Technical Bulletin

DP02	TB0041-2011	Élan Motorsports Technologies	
From:	John Harris		
Subject:	2.0L MZR Engine Install	Date:	Nov 22nd, 2011

Figure 1: Bellhousing Shims

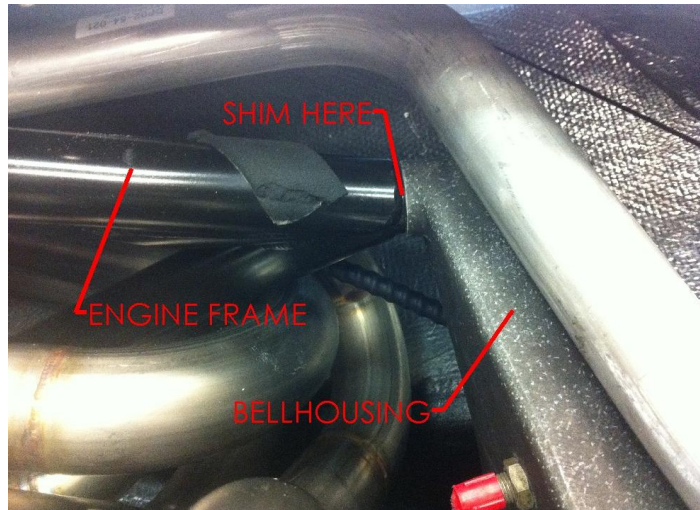
It is worth noting that, due to manufacturing tolerances, all DP02 chassis were originally assembled with the appropriate amount of shims between the bellhousing and engine frame bosses (see Figure 1). This is to ensure the bellhousing does not crack due to stresses induced during installation. The conversion of any DP02 chassis to accept a new motor will inevitably require this shimming process to be repeated.

9. Tighten the three bolts securing the front upper engine mount to the engine.
10. Using a pair of calipers, carefully measure the gap between the bellhousing and the engine frame bosses at all four mounting locations. Acquire the corresponding thickness and amount of shims required to take up the gap at these four locations.

11. Remove bellhousing and engine. Install shims in their appropriate locations.
12. Reinstall bellhousing, engine and included mounts leaving **all** fasteners loose.
